Access Compliance Report Public Rights-of-Way (Curb Ramps)

Main Street: **OSO_PKWY** Cross Street: **MORNING_TRAIL** Location: **SE**

ADA ID: **RPRK211021124247** Ramp Type: **Type 1 - Perpendicular Diagonal Initial Pass/Fail: Fail** Overall Compliance: **No** Severity Score: **16**

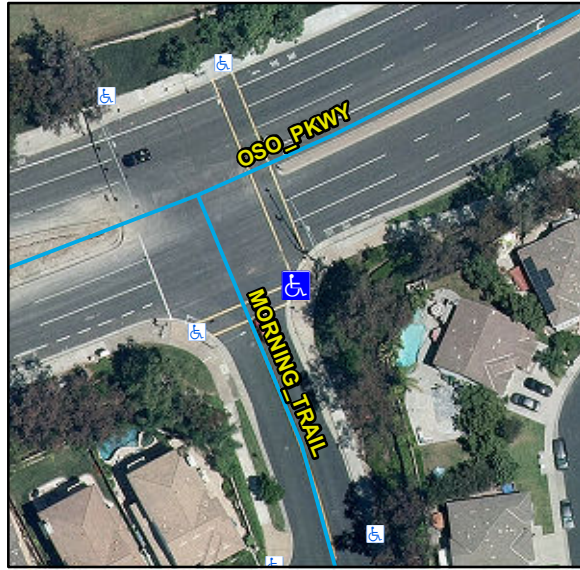
R304.2.2, R204.3, R304.5.3, STD 1115

Compliance	Description	Data	Compliance	Description	Data
N/A	Ramp Length (in)	96	N/A	Flare Type LT	
Yes	Ramp Width (in)	48			N/A
No	Ramp Run Slope (%)	11.4	N/A	Flare Slope LT (%)	N/A
No	Ramp Cross Slope (%)	2.6	N/A	Flare Traversable LT	N/A
N/A	Landing Present	N/A	N/A	Flare Type RT	
N/A	Landing Length (in)	N/A			N/A
N/A	Landing Width (in)	N/A	N/A	Flare Slope RT (%)	N/A
N/A	Landing Run Slope (%)	N/A	N/A	Flare Traversable RT	N/A
N/A	Landing Cross Slope (%)	N/A	N/A	DWS Provided	N/A
N/A	Landing Movement Obstructed?	N/A	N/A	DWS Contrast	N/A
	Landing Movement Type	N/A	N/A	DWS Length (in)	N/A
N/A	Landing Shared	N/A	N/A	DWS Full Width	N/A
N/A	Clear Space	Yes	N/A	DWS Offset Left (in)	N/A
N/A	Clear Space To Crosswalk (in)	48	N/A	DWS Offset Right (in)	N/A
N/A	Marked Crosswalk 1	Yes	N/A	Marked Crosswalk 2	Yes
	Crossing 1 Direction	N		Crossing 2 Direction	W
	Marked Crosswalk 1 Width (in)	144		Marked Crosswalk 2 Width (in)	144

Remove & Replace Curb Ramp With Two New Directional Ramps or Equivalent.
